Date	Group	No.	Release	Page
7.2016	<b>252</b>	<b>033</b>	<b>02</b>	1(4)

## Exhaust Heat Shield, Installation CHU, CXU

### FSB 252-033, Exhaust Heat Shield, Installation

(July 2016)

W2113926

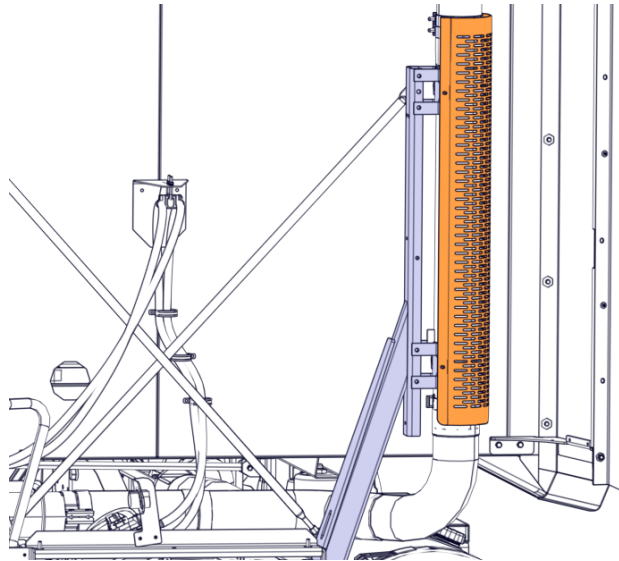
MACK CHU and CXU models equipped with sleeper cab and without side air deflectors, built between May 5, 2014 and May 16, 2016, did not come with lower exhaust elbow heat shields. If these vehicles have or are later equipped with rear PTO, the operator may be exposed to high temperature exhaust components. Customers have raised concerns about having a heat shield on previous model units. There is concern that the operator may accidentally contact the exhaust when working behind the cab.

**Note:** The long upper heat shield must be replaced with the short upper heat shield

- 1 Secure the vehicle for service by parking it on a flat level surface, applying the parking brake, chocking the rear wheels, and placing the transmission in neutral or park.
- 2 Remove the long upper heat shield.

- 3 Install the short upper heat shield.
- 4 Tighten upper heat shield bolts to 24 Nm (18 lb-ft).

W2111563

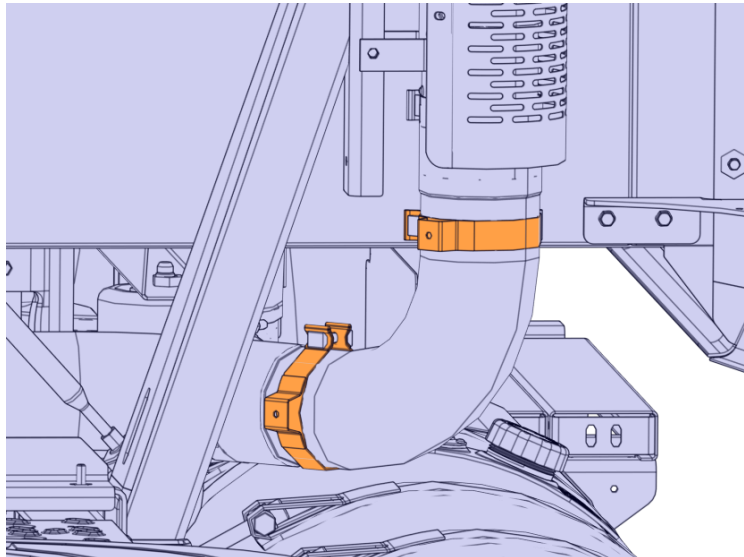
- 5 Loosely install brackets on exhaust pipe. Use heat shield to position brackets.

**Note:** Slotted holes at the top.

W2111562

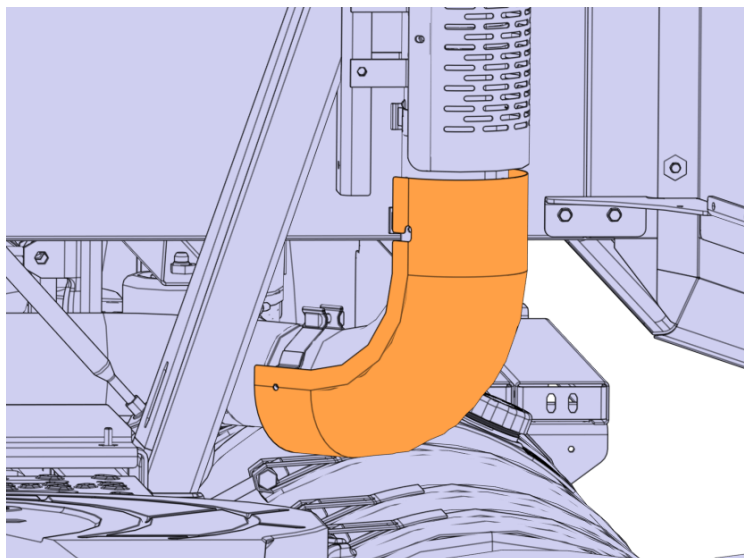
- 6 Secure heat shield to brackets.

- 7 Tighten mounting bracket bolts to  $40 \pm 5$  Nm ( $30 \pm 4$  lb-ft).
- 8 Secure heat shield bolts.
- 9 Tighten heat shield bolts to 24 Nm (18 lb-ft).
- 10 Remove the wheel chocks.
